GAFFNEY BOARD OF PUBLIC WORKS

I-85 SEWER EXTENSION  
CONTRACT 1C – COLLECTIONS

ADDENDUM NO. 6

January 10, 2024

S-01-102A

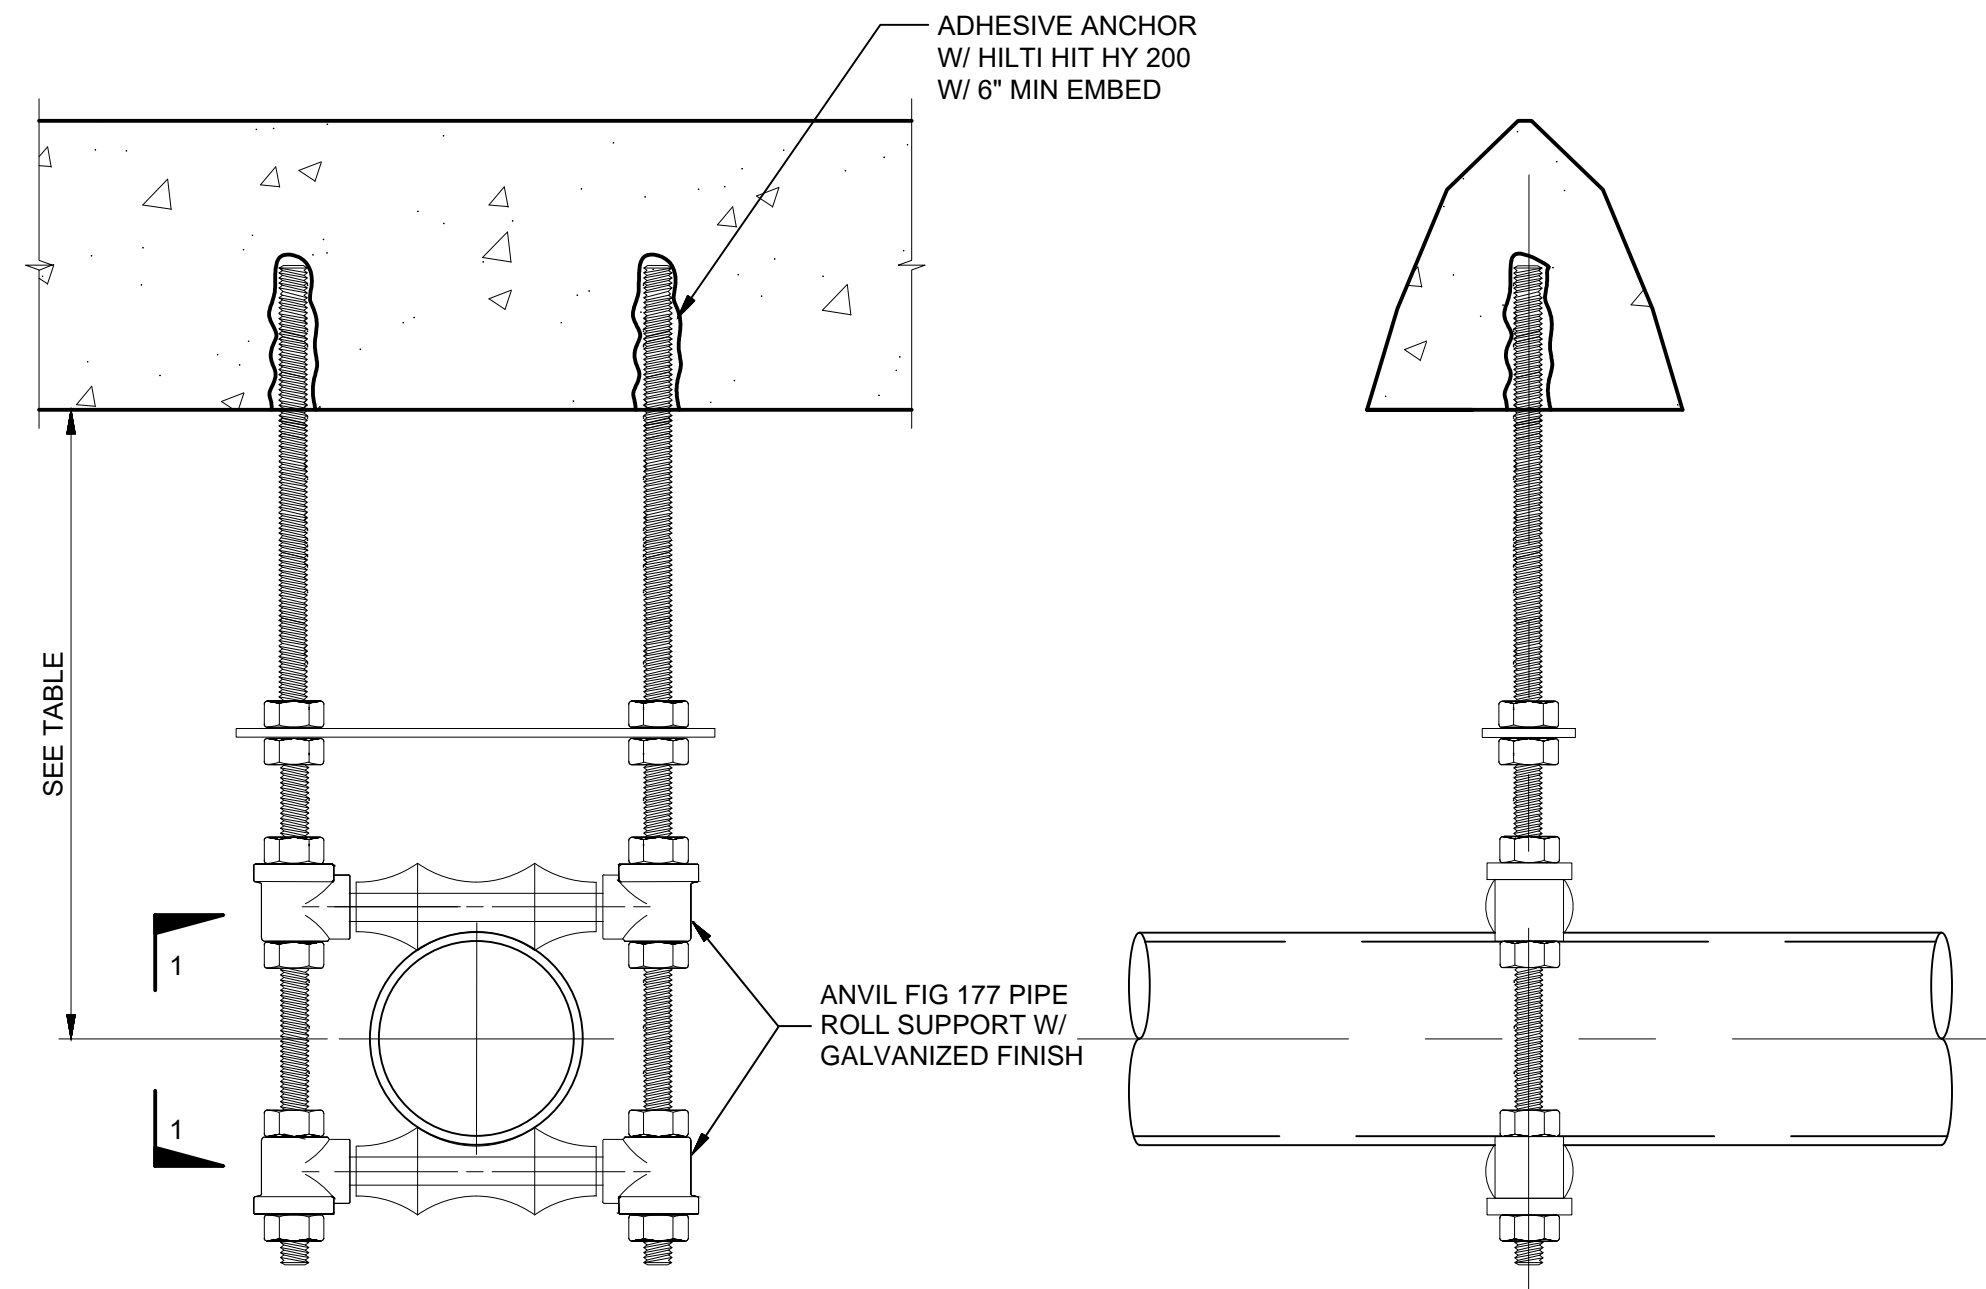
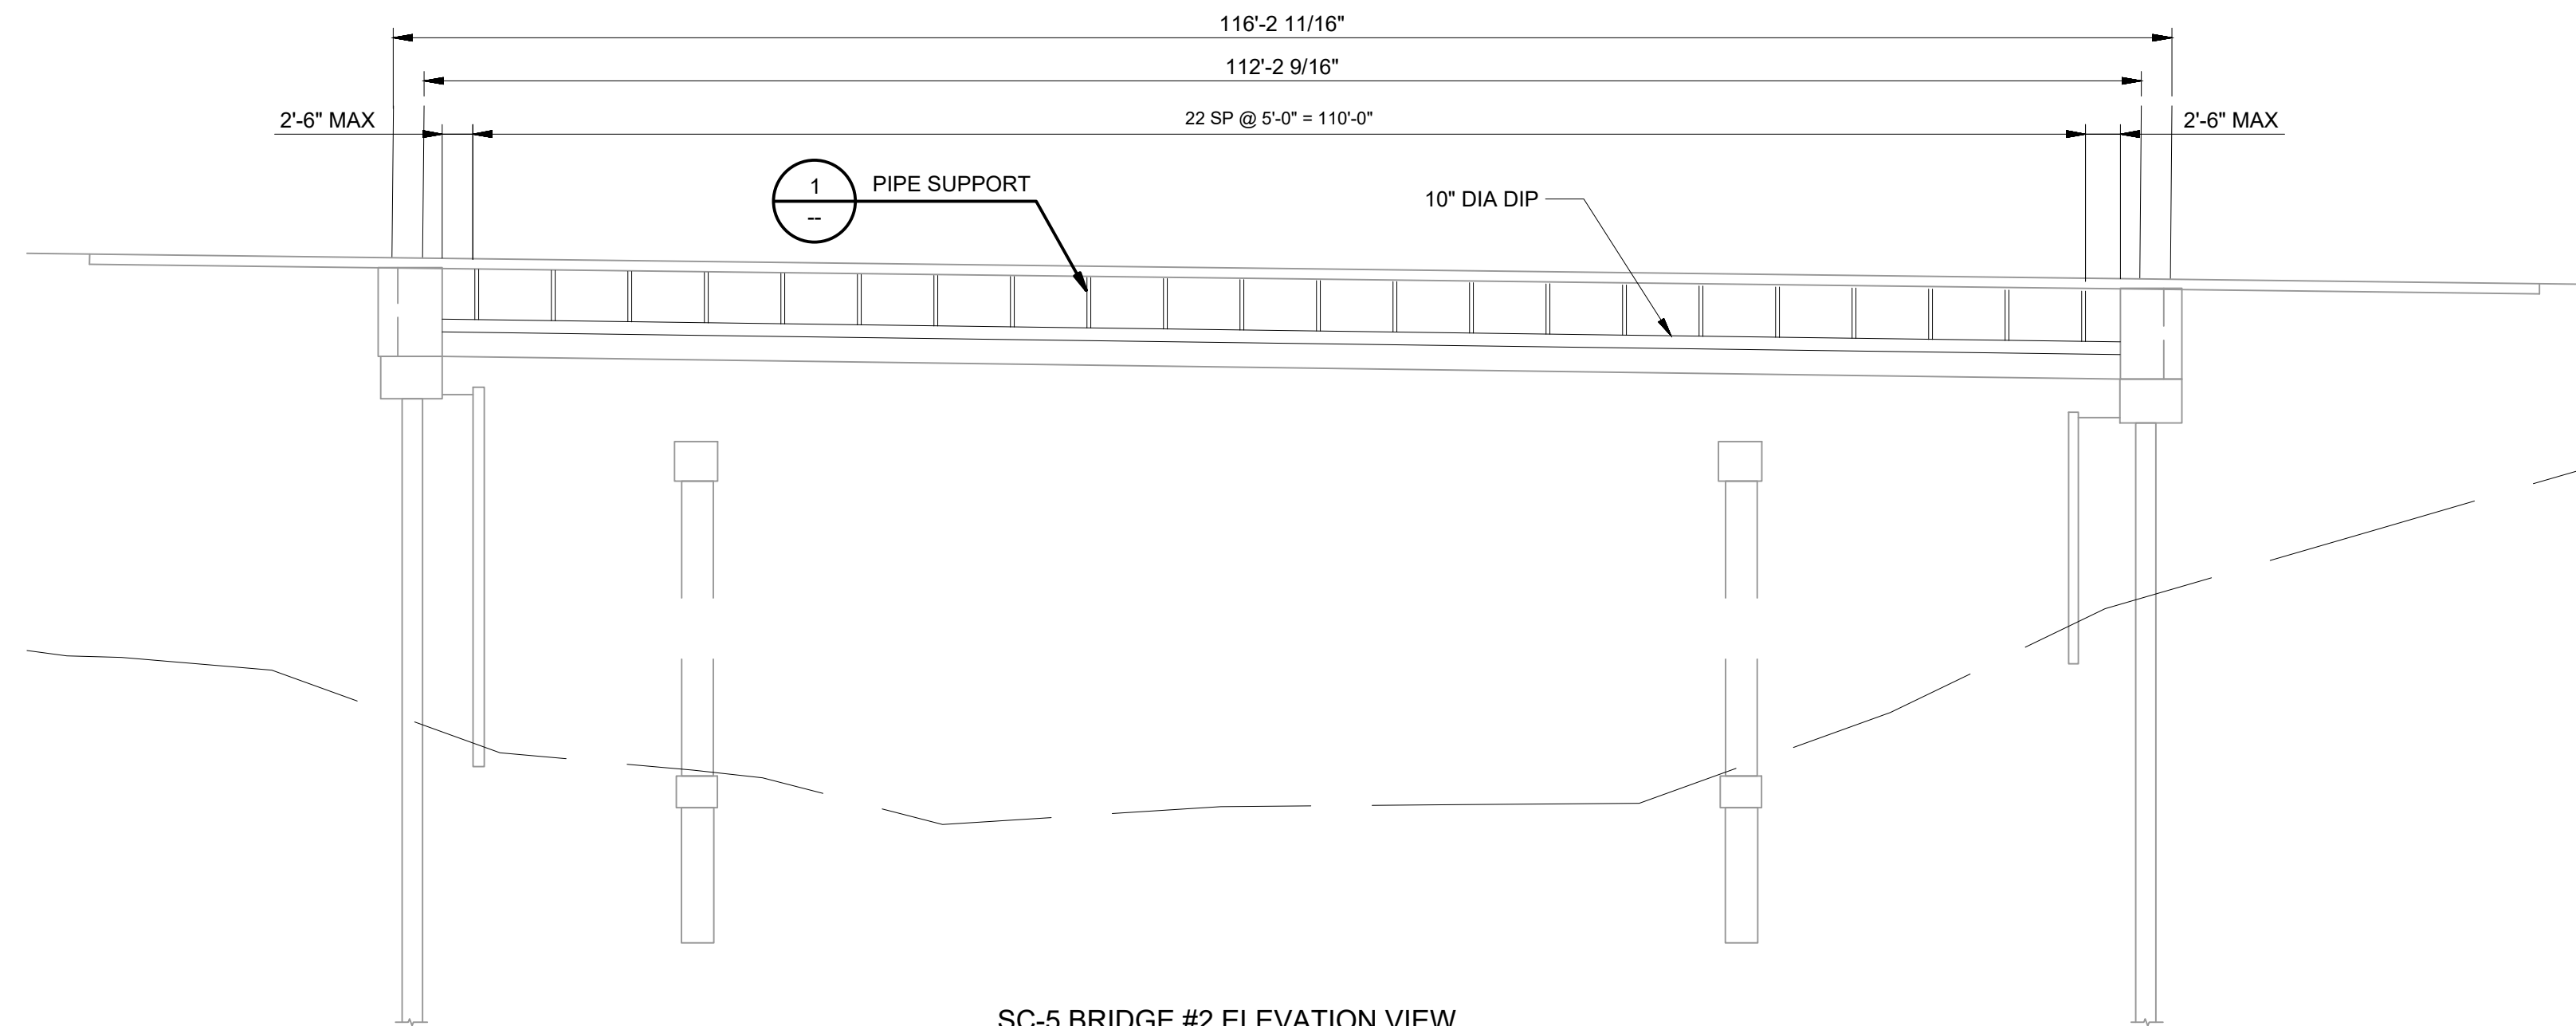
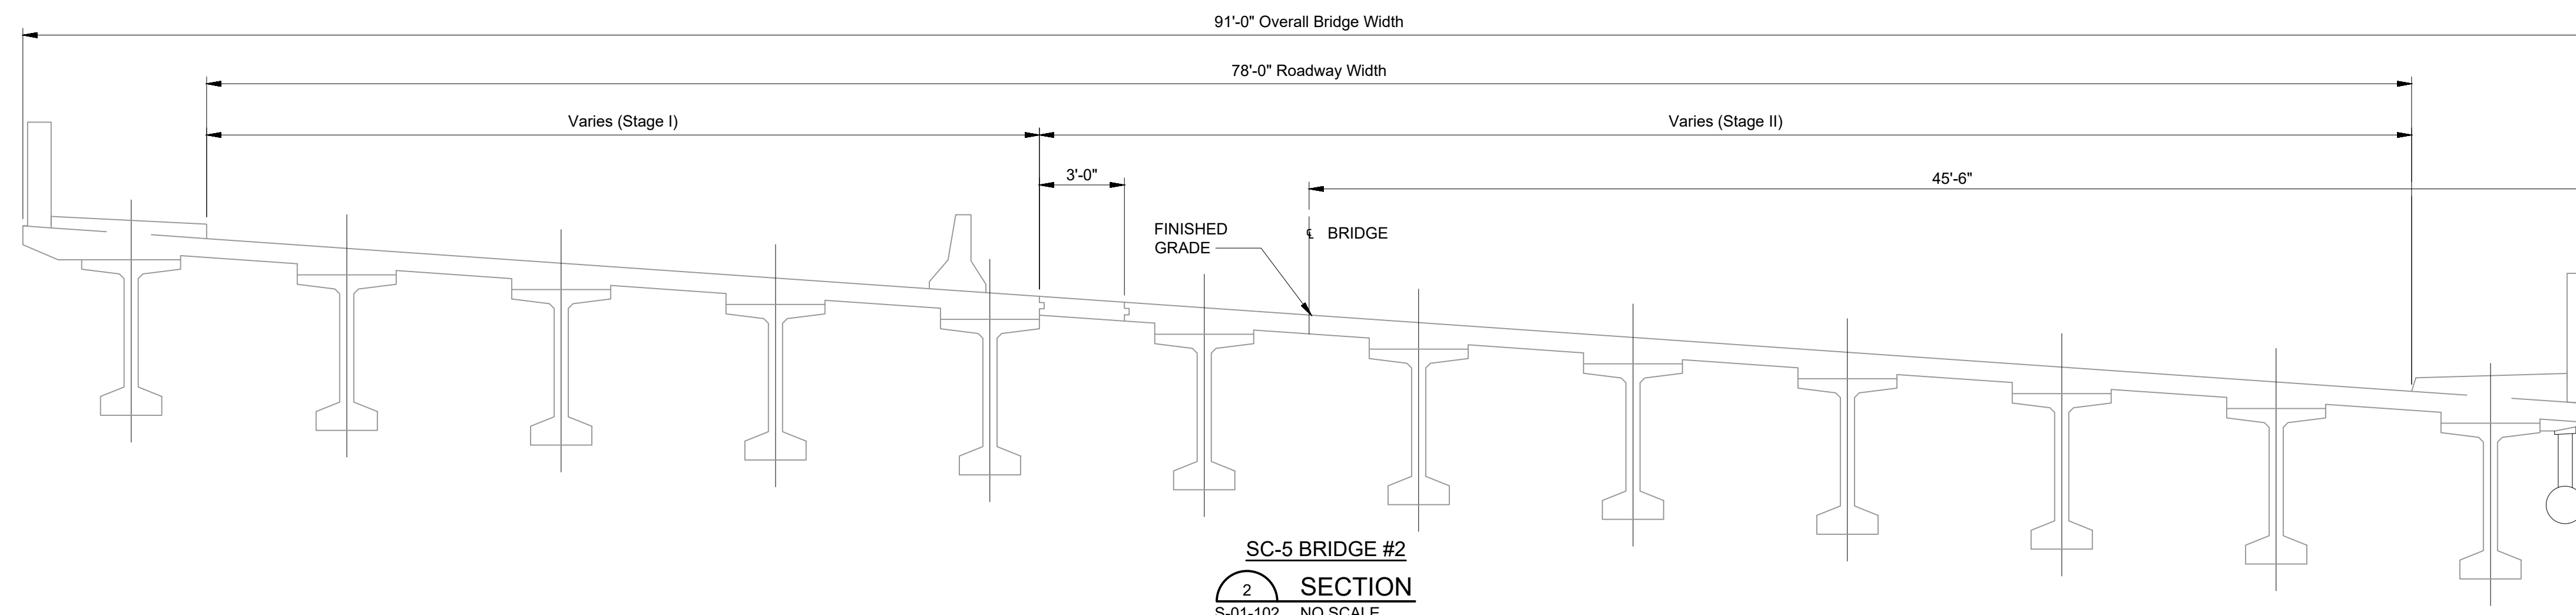
- i. Insert the attached new sheets C-06-103A and C-06-104A for Segment 6 Alternative 1 and the new sheet C-08-102A for Segment 8 Alternative 2 after sheet C-16-109.
- ii. Insert the attached new sheets S-00-001, S-01-101A, and S-01-102A for the Alternatives after sheet C-99-006.
